Serial No. NA3-11-019R
Docket No. 52-017
COL/MWH

DOMINION VIRGINIA POWER
NORTH ANNA UNIT 3 COMBINED LICENSE APPLICATION
SRP 03.07.01 AND 03.07.02: RESPONSE TO RAI LETTER 64

RAI 5544 Question 03.07.01-4

RAI 5546 Question 03.07.02-2

Figure 1 - R/B Complex Mass Participation (N-S direction)

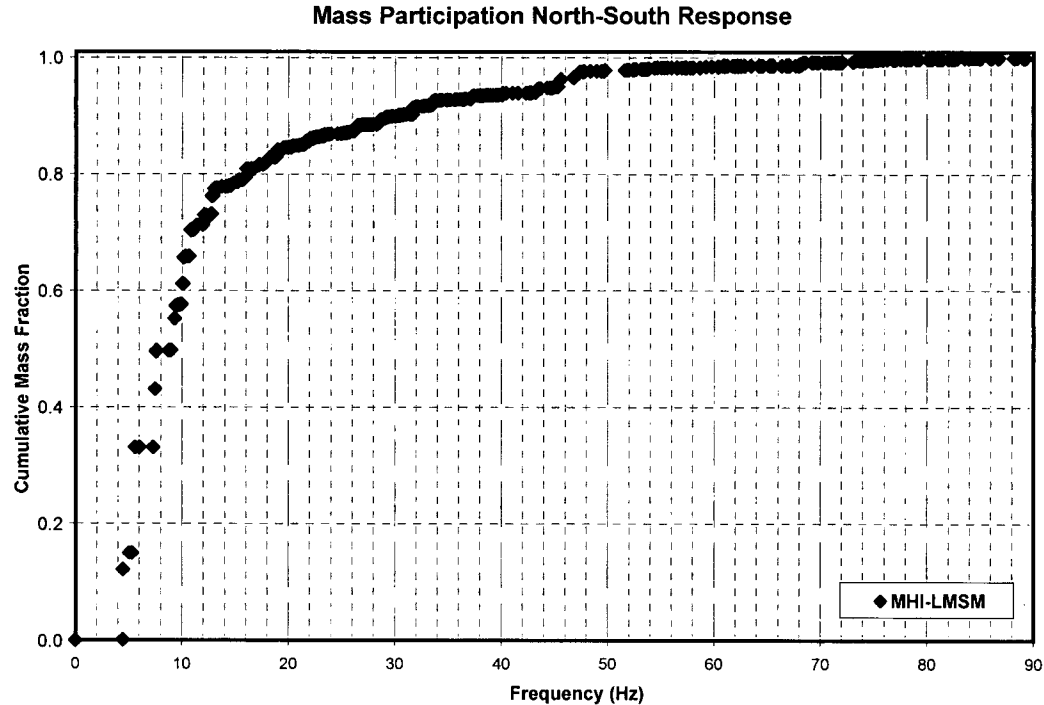
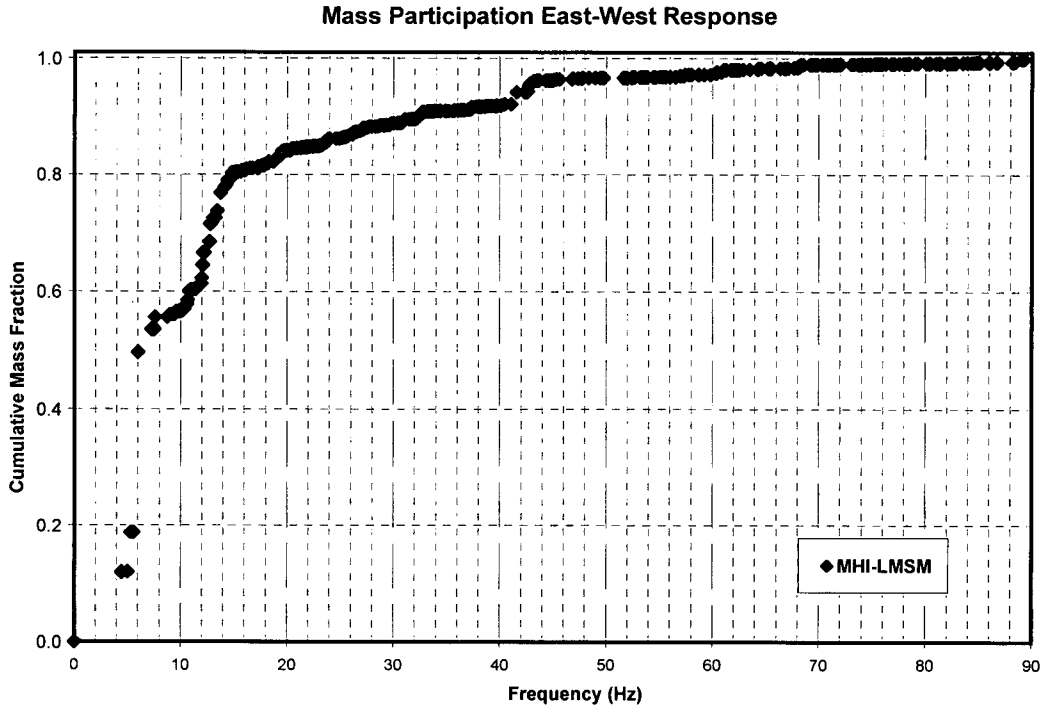
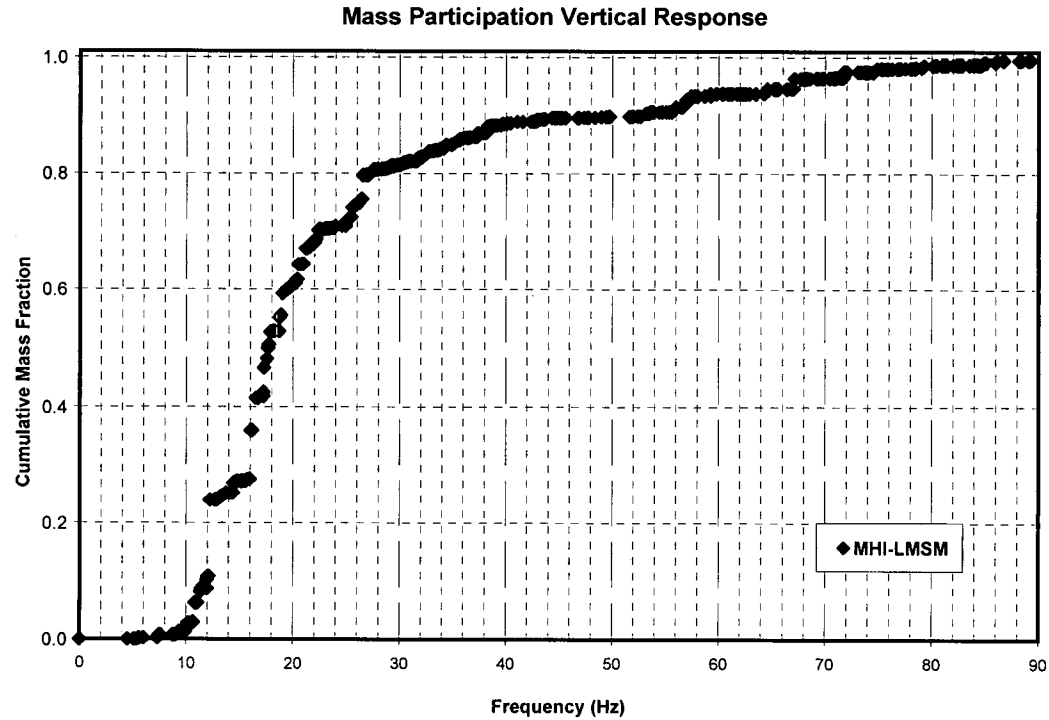
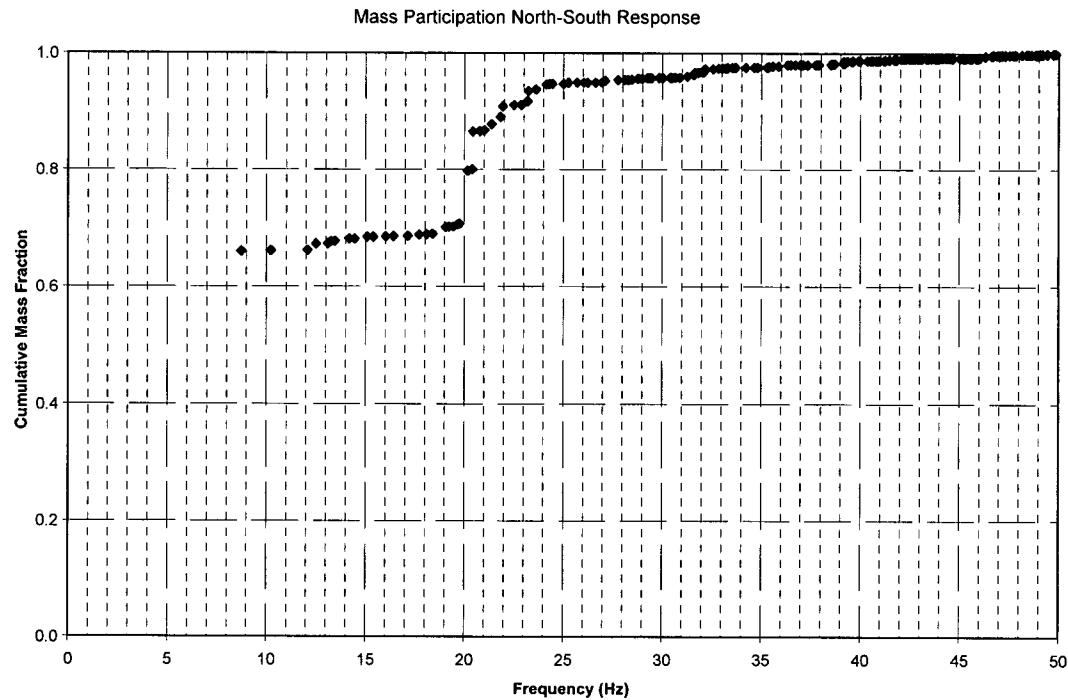
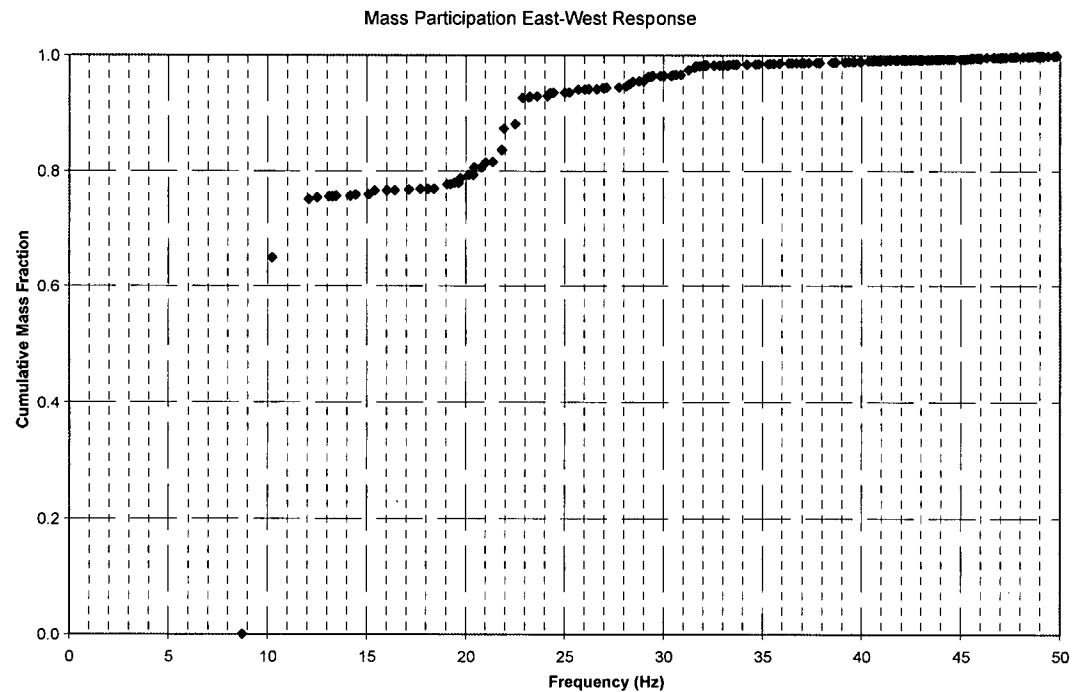
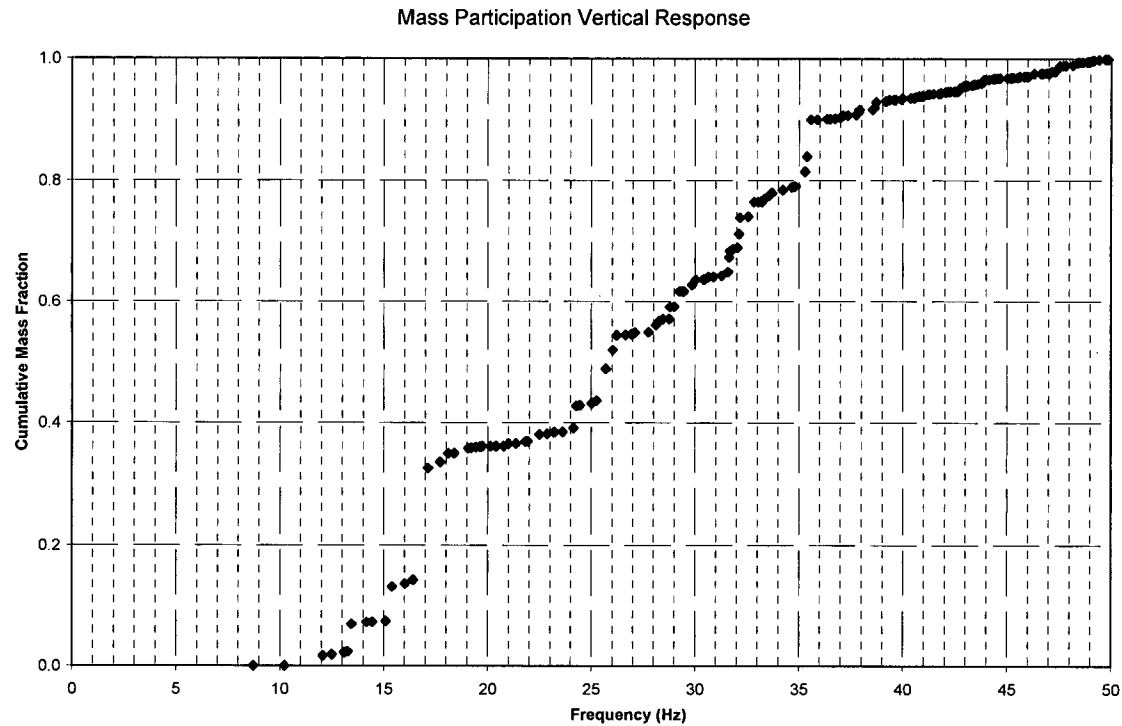
- 1) A summary of modal characteristics in the fixed-base condition, including the natural frequencies, effective modal masses, percent of mass participation, cumulative percent of mass participation, total number of modes included in the analysis, and method used to account for missing mass modes, for each of the standard plant Category I structures.

A fixed base modal analysis was performed on the Lumped Mass Stick models used for the North Anna Unit 3 site-specific SSI analyses of R/B Complex in order to extract natural frequencies, effective modal masses, percent of mass participation and cumulative percent of mass participation for the first 500 modes. Figure 1 through Figure 3 present the graphs of the cumulative mass participation vs. frequency for the fixed base response of the R/B Complex in three directions. The larger "jumps" in the plots indicate dominant modes of vibration of the structures with major mass contributions. Table 1 through Table 3 summarize the results for the dominant modes and respective modal characteristics for the response of the R/B Complex lumped mass stick model in N-S, E-W and vertical direction. The dominant modes of vibration of PCCV in each direction and their respective characteristics are presented in Table 4 through Table 6. Table 7 through Table 9 present the dominant modes of vibration in each direction and respective modal characteristics for the CIS lumped mass stick model.

Plots of transfer function amplitudes obtained from the ACS SASSI analysis of the R/B Complex lumped mass stick model resting on the surface of rigid half-space are presented in MUAP-10001(R1). Figures 5.3.3.2-1, 2 and 3 present the plots of transfer function amplitudes for the response of the PCCV lumped mass stick model in N-S, E-W and vertical direction. Figures 5.3.4.2-1, 2 and 3 present the plots of transfer function amplitudes for the response of the R/B Complex lumped mass stick model, and 5.3.5.2-1, 2 and 3 present the plots of transfer function amplitudes for the response of the CIS lumped mass stick model. The plots show peak amplifications in the transfer function amplitudes at frequencies near those of the dominant modes of vibrations provided in the Table 1 through Table 9 below.

Table 10 through Table 12 present the dominant modes of vibration of PS/B dynamic FE model in each direction and the respective modal characteristics. These dominant modes of vibration for PS/B with major mass participations are depicted in Figure 4 through Figure 6 as "jumps" in the cumulative mass participation graphs.

Figure 23 - NEI Check of Horizontal FIRS for East PS/B

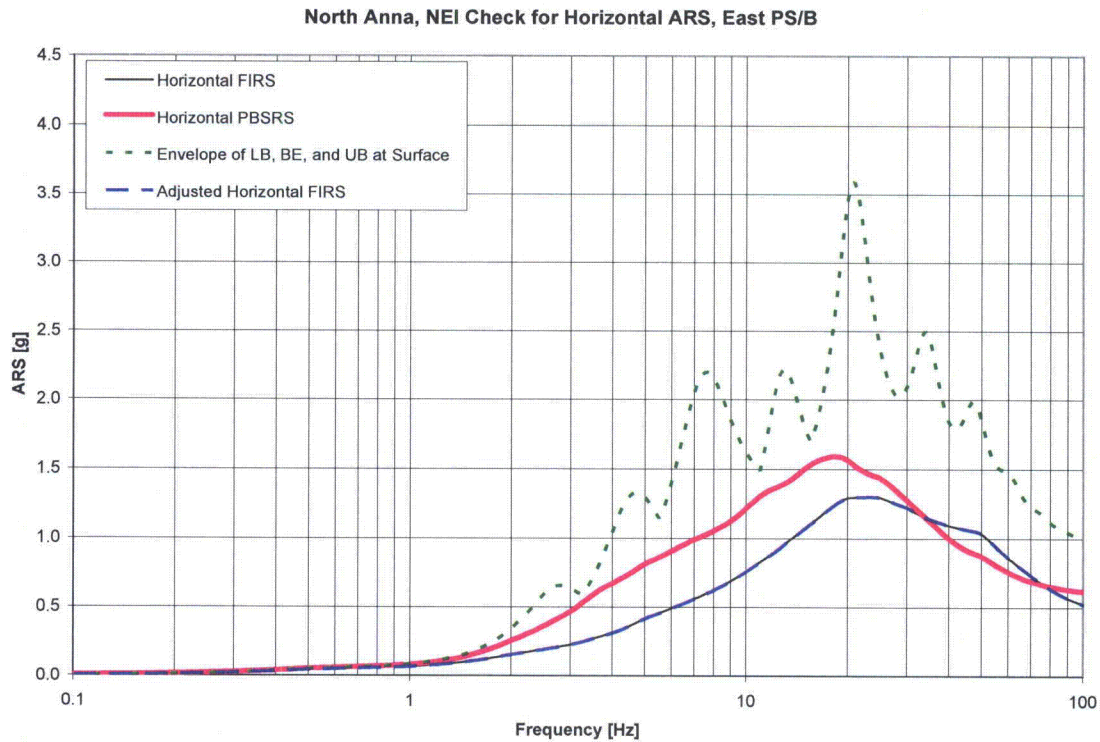
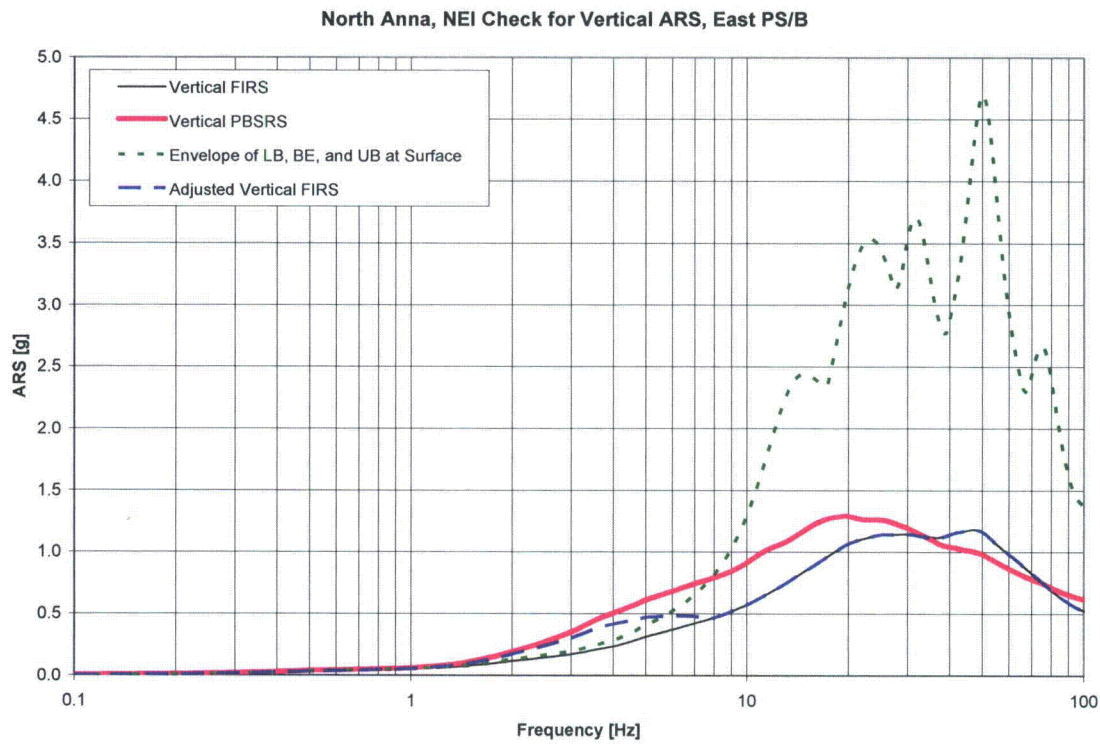
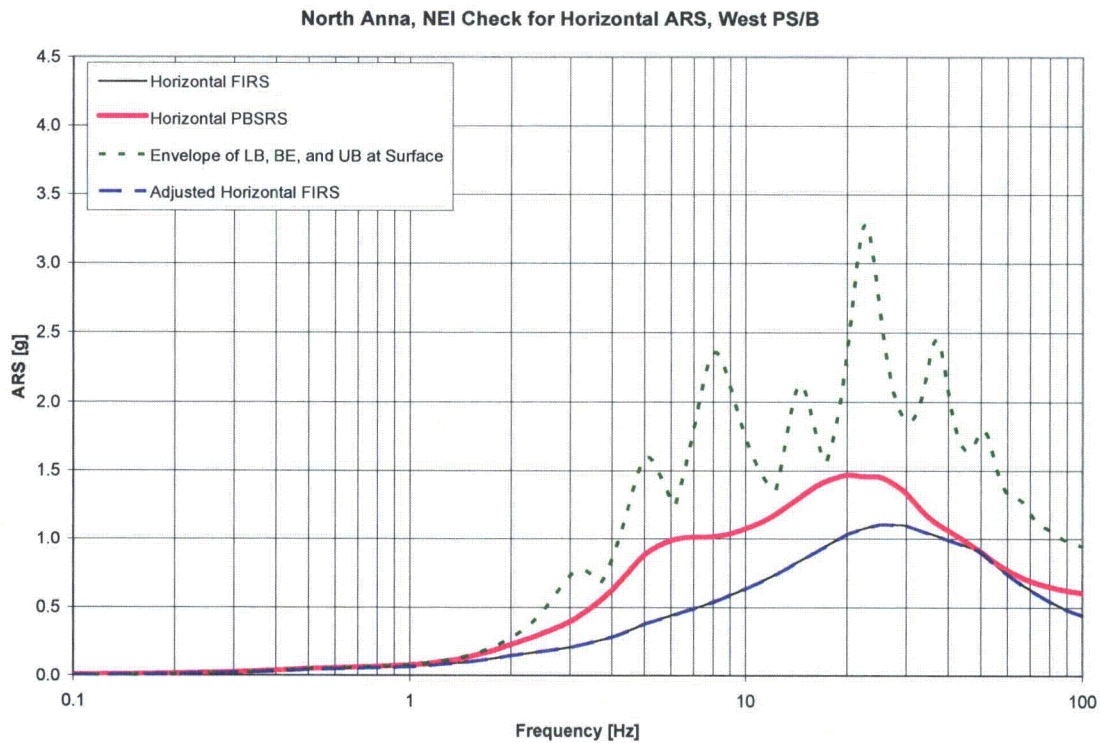
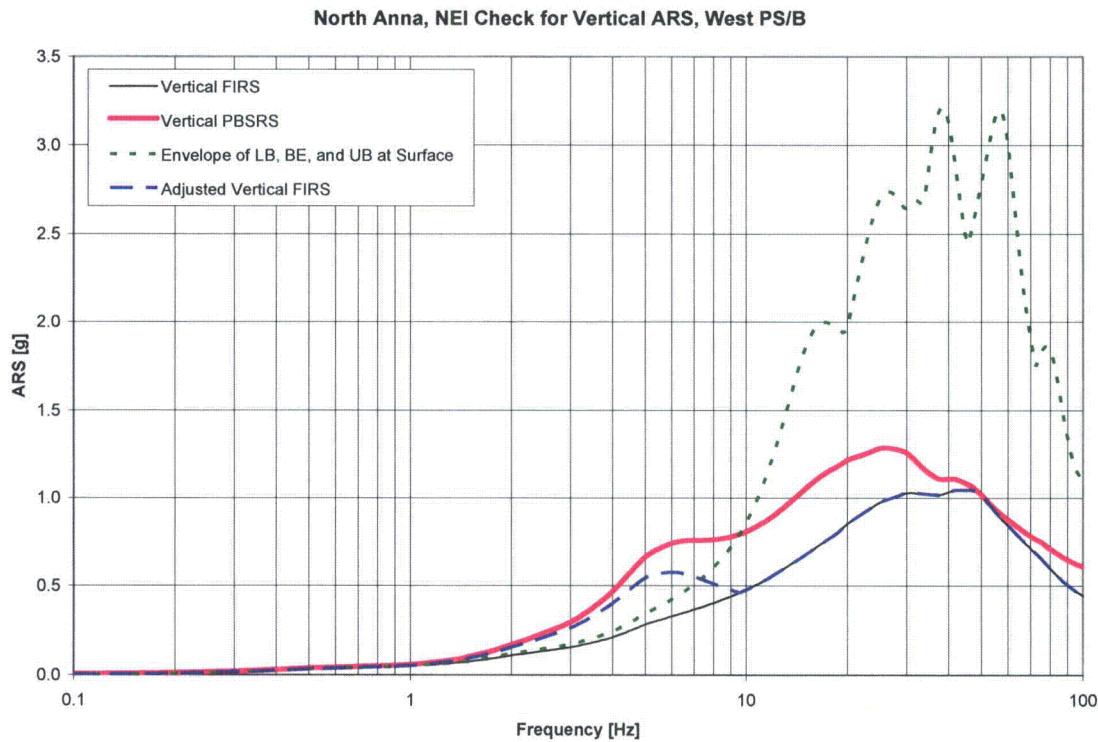
- 12) Verification of the adequacy of the Foundation Input Response Spectra (FIRS) as SSI input motions ("NEI Check" as described in FSAR, Section 300.1.4) for all embedded structures.
-

The NEI check and adjusted FIRS for East Power Source Building (PS/B) in the horizontal and vertical directions are provided in Figure 23 and Figure 24, respectively. The adjustment for horizontal spectrum occurs at frequencies less than 0.30 Hz with the maximum factor of 1.09. For the vertical spectrum the modification is more pronounced and occurs at frequencies less than 7.8 Hz with a maximum factor of 1.83 at 3.5 Hz.

The NEI check and adjusted FIRS for West PS/B in the horizontal and vertical directions are provided in Figure 25 and Figure 26, respectively. As described in FSAR 300.1.4, the adjusted FIRS are smoothed to obtain Soil Structure Interaction (SSI) input motions. Note that the adjusted FIRS for the East and West PS/Bs are enveloped prior to smoothing to constitute the SSI input motion for the PS/Bs. The adjustment for horizontal spectrum occurs at frequencies less than 0.29 Hz with the maximum factor of 1.09. For the vertical spectrum the modification is more pronounced and occurs at frequencies less than 9.3 Hz with a maximum factor of 1.93 at 4.6 Hz.
